7800 Series Graphic Keypads

June 2014

Version 105 Software Update

TU-0732 © 2014 Digital Monitoring Products, Inc.

Select Language Screen

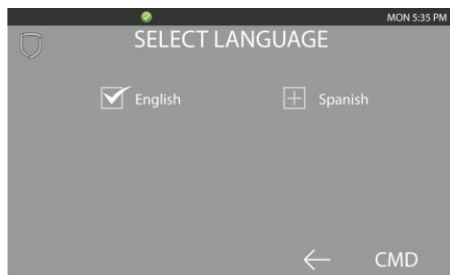
7800 Series Graphic Keypads can now be programmed to display Spanish text in the Home Screen and screens accessed from the Carousel Menu. A new Select Language screen has been added to the Installer Options menu just after Shortcut Items.

The Select Language screen allows you to select the language for text on the Home Screen and Carousel Menu Screens. Press the item to select and a check mark displays. Press again to de-select. The keypad does not translate information from the panel displayed in the Keypad screen such as the Status list. Only one language may be selected. Default is English.
